Sub: Submission of Joint Committee Report in OA. 1248/2024 titled as Kissan Udey Samiti Versus State of Haryana & Ors - reg.

Report of the Joint Committee in compliance to the Order of Hon'ble National Green Tribunal dated 18.09.2025 in the matter of OA No. 1248/2024 (IA No. 516/2024 and 517/2024); Kissan Udey Samiti Versus State of Haryana & Ors.

Committee Inspection Report on dated 03/11/2025

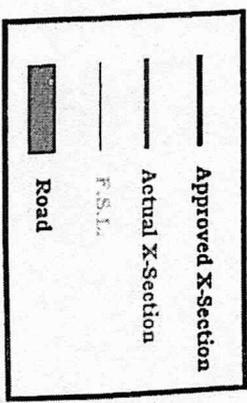
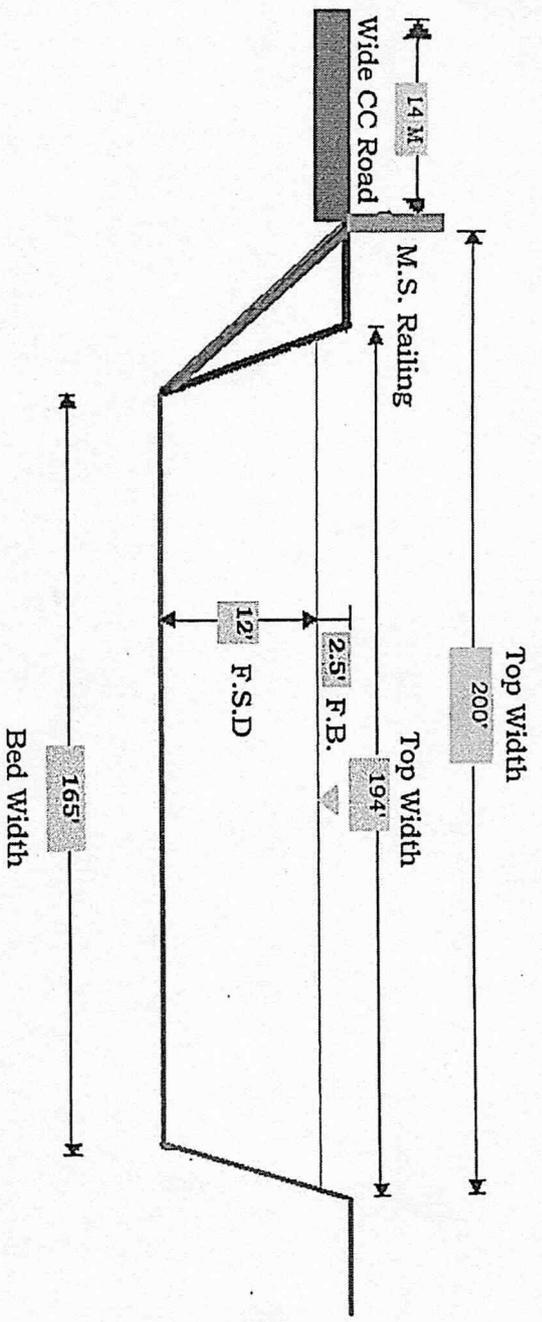
S.No.	RD	As per Design		As per Measurement		
		Bed Width	Top Width	Bed Width	Top Width	Road Width
1	24900	165'	194'	178'	207'	-----
2	25100	165'	194'	165'	203'	14 mtr
3	25900	165'	194'	165'	200'	14 mtr

Hence, no obstructions were found which can create any hinderance in the flow of drain and no discharge is reduced against its design discharge 7320 Cs. The drain is fully capable for carrying the design discharge.

X-Section at RD 25900

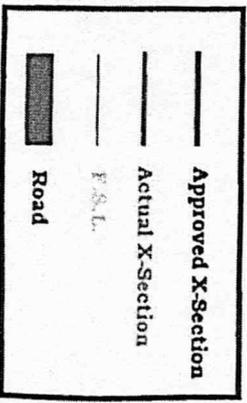
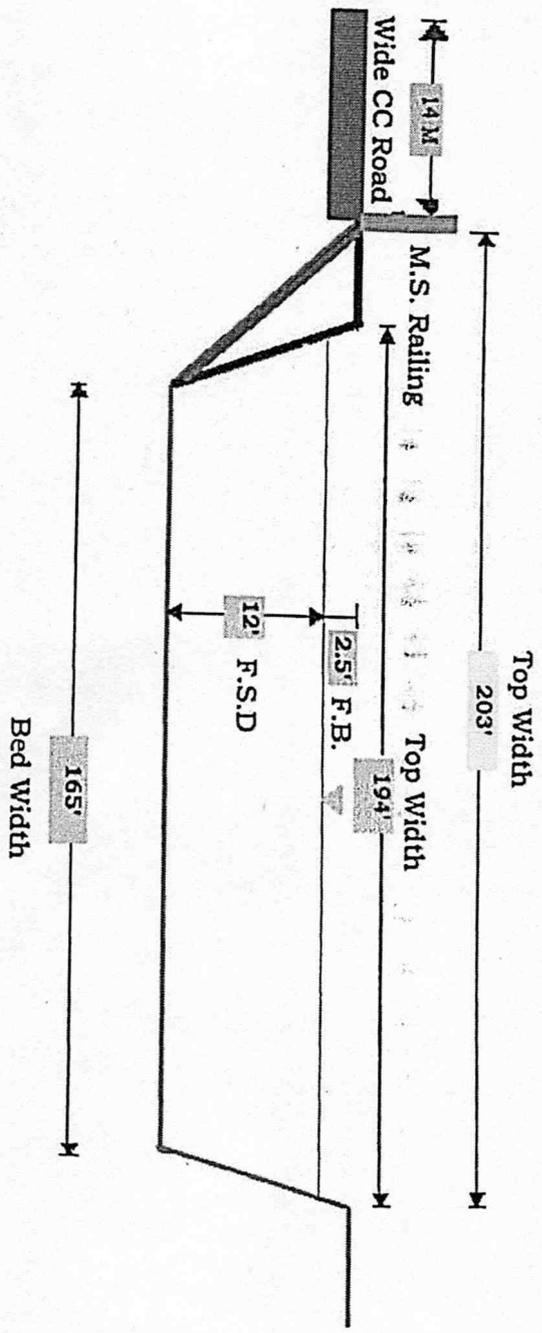
- vi) From the above measurement carried out by the Respondent No. 07 in the presence of the Joint Committee, it may be concluded that:
- At present, the bed width of the Drain No 8 at X Section at RD 25100 and X Section RD 25900 is 165 ft, which is same (165 mtr) as given in the approved X Section.*

- At present, the top width of the Drain No. 8 is 203 ft and 200 ft at X Section at RD 25100 and X Section at RD 25900 respectively, which is well within the top width of 194 ft as given in the approved X Section.*

- The road width as per measurement carried out in the presence of the Joint Committee is 14 mtr, which is within the 15 mtr width as permitted by Commissioner and Secretary to Govt. of Haryana, Irrigation and Water Resources Department, Haryana to M/s Design Promoters Pvt. Ltd. vide Memo No. 1/W-450008/54/2023 dated 28/12/2023, for construction of 15 mtr. wide road within the right of way of Diversion Drain No. 8 from RD 25100 to RD 25900 left side.*
